# FOUNDATION LUTHERAN CHURCH

## GRADING AND EROSION CONTROL CONSTRUCTION DOCUMENTS

SHEET NAME  
GEC COVER

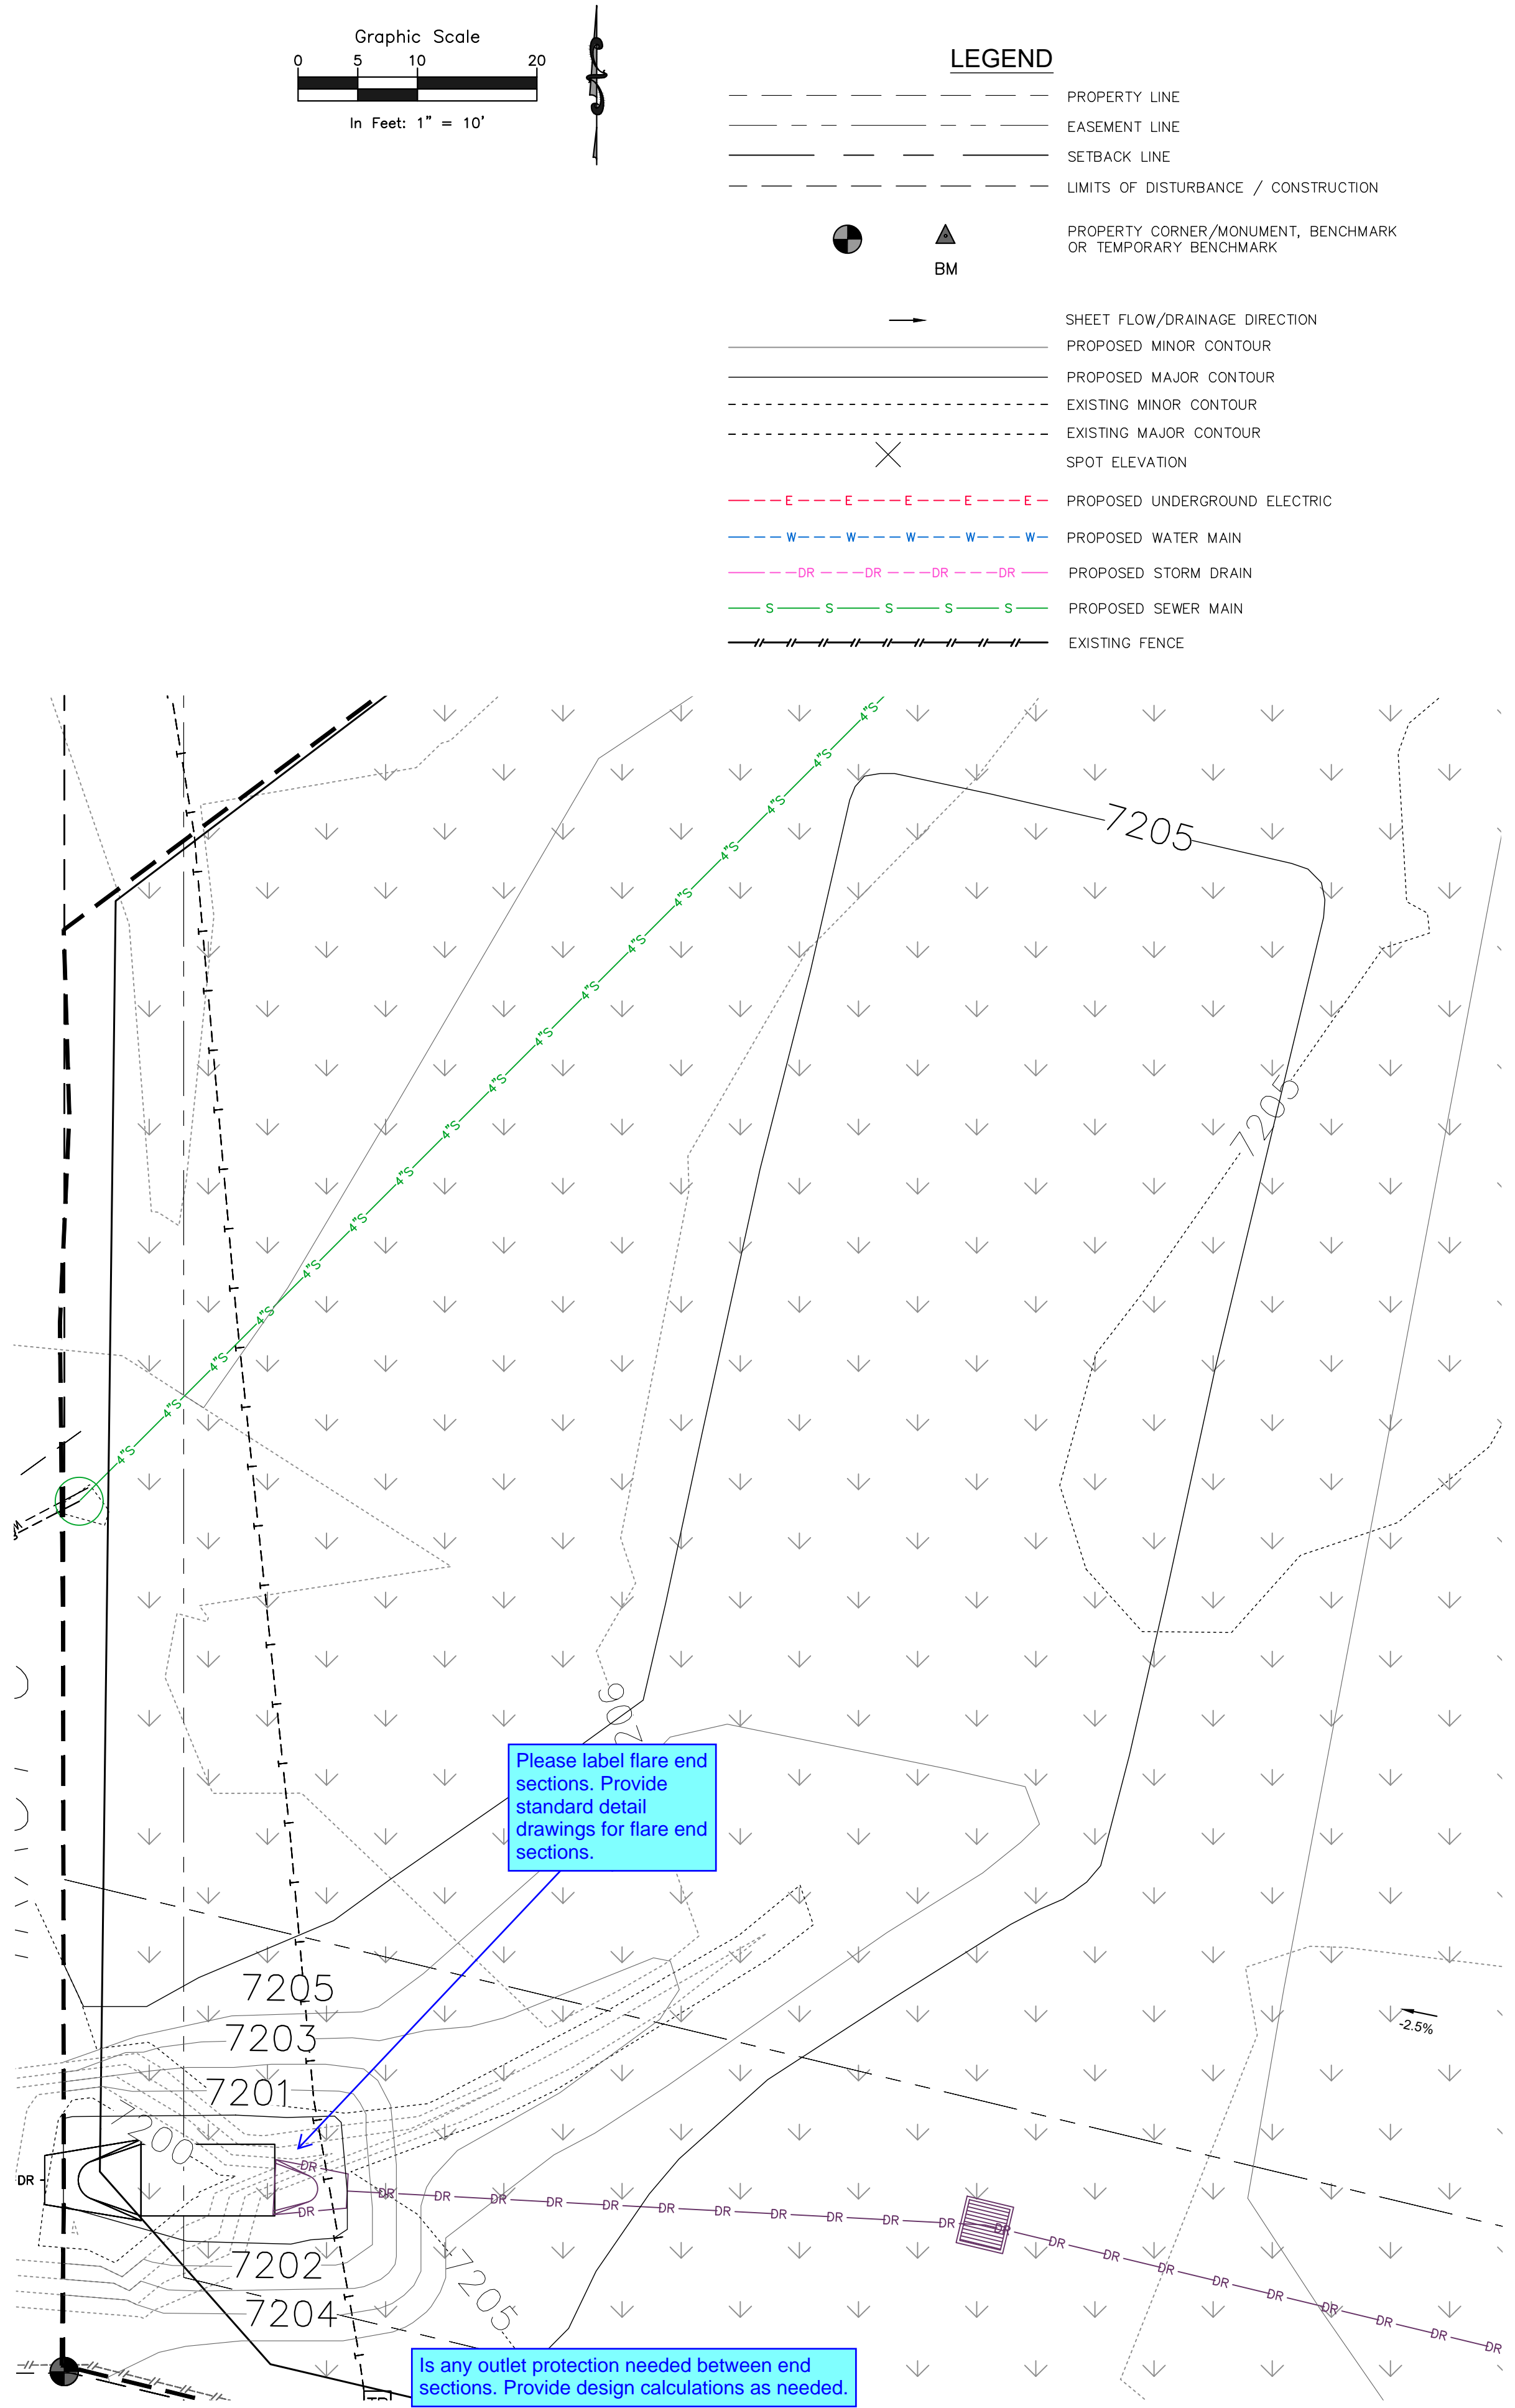
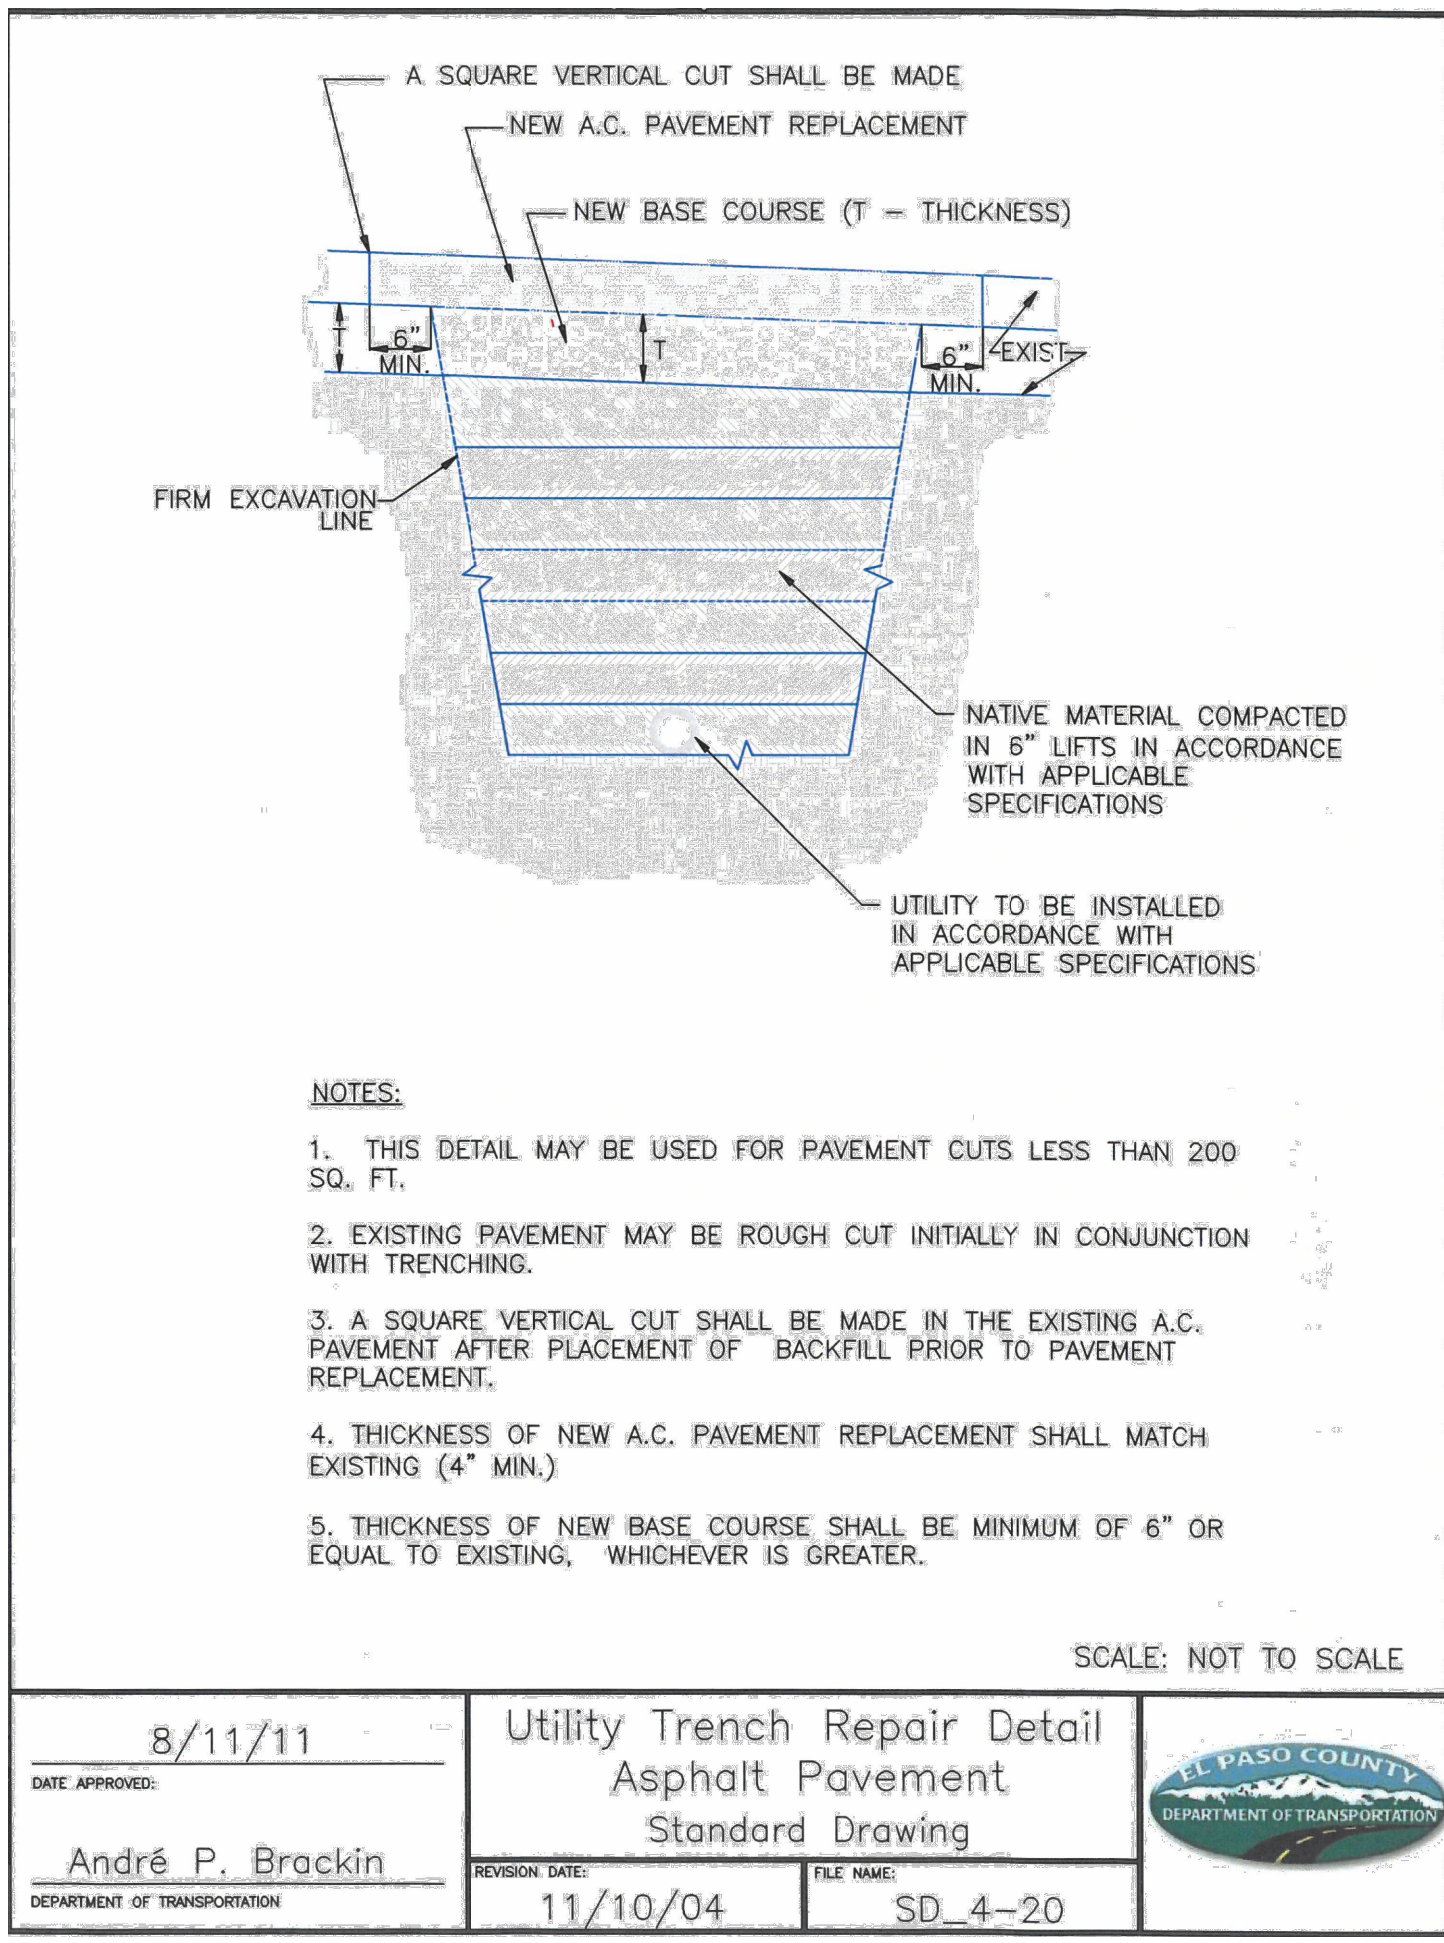
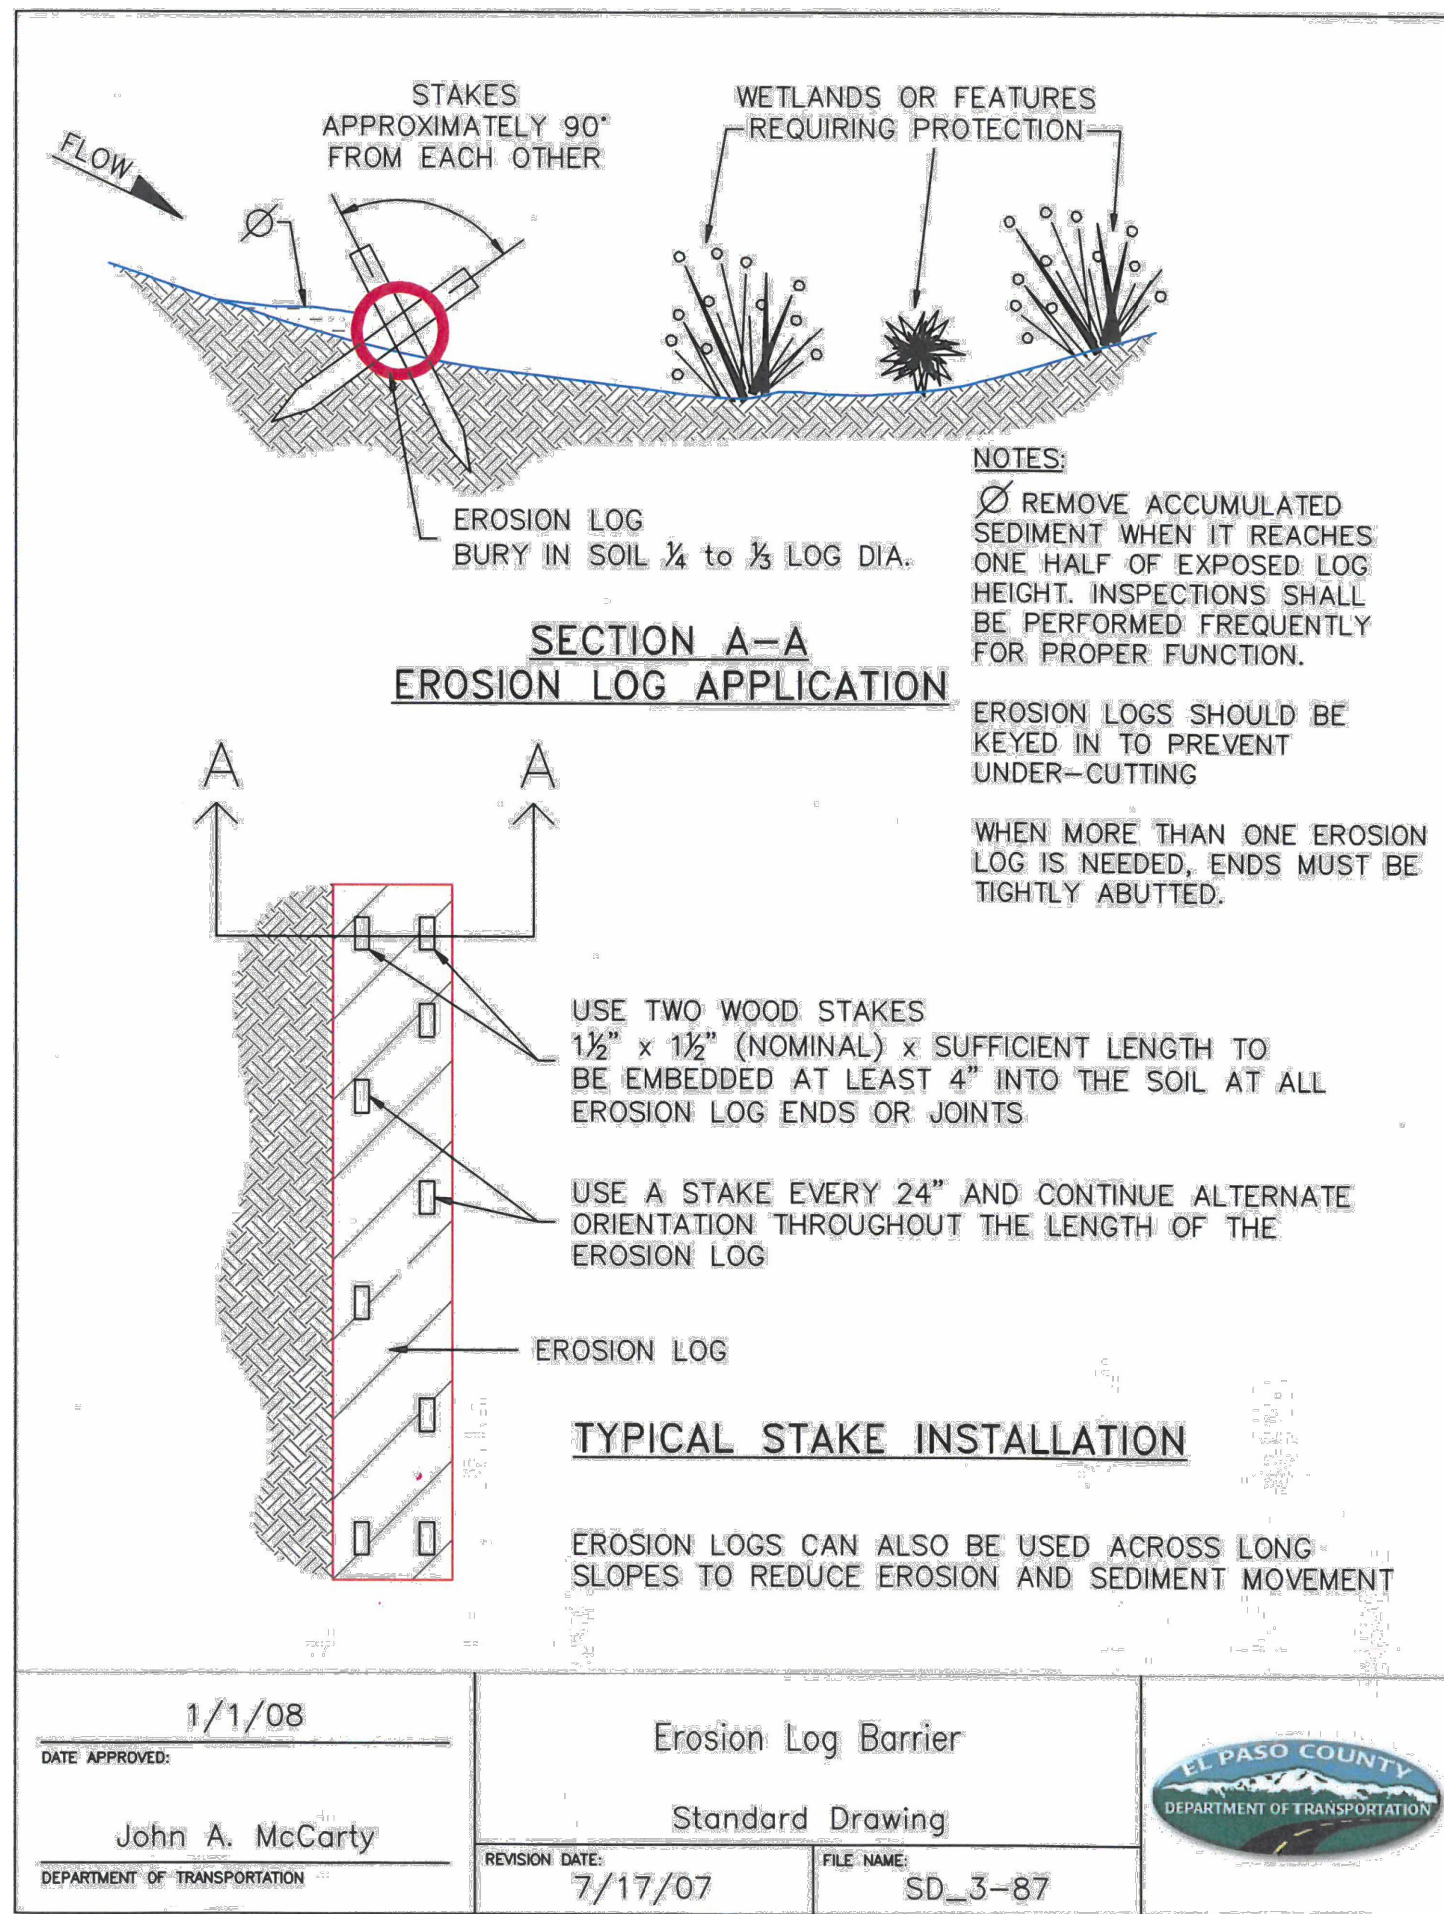
Should this be south?
